DEVELOPMENT CONTROL AGENDA

- 11. OBJECTING STATEMENT - 25 HALL PARK GATE (Pages 2 - 11)**

PLANNING OBJECTION – 4/00524/16FUL - 25 Hall Park Gate New Planning Application & Amended drawings

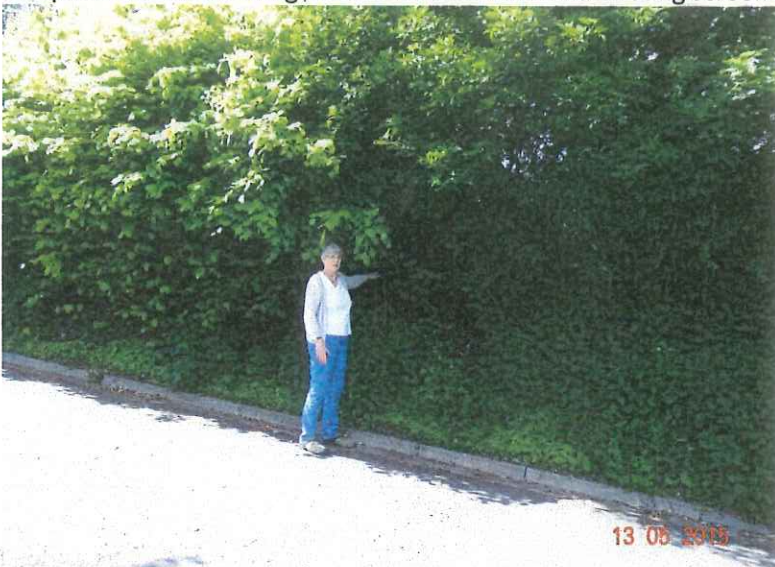
It can be seen from the front elevation to Fieldway [see above] that contrary their statement the existing high hedge at the rear of No 25 will not be retained. Instead there is low level screening for part of the frontage to the height of a car - below the height of the windows and front door. This is likely to be at the level of the current bank and provides minimal screening of the house.

See photo below showing level of current bank and existing screening:
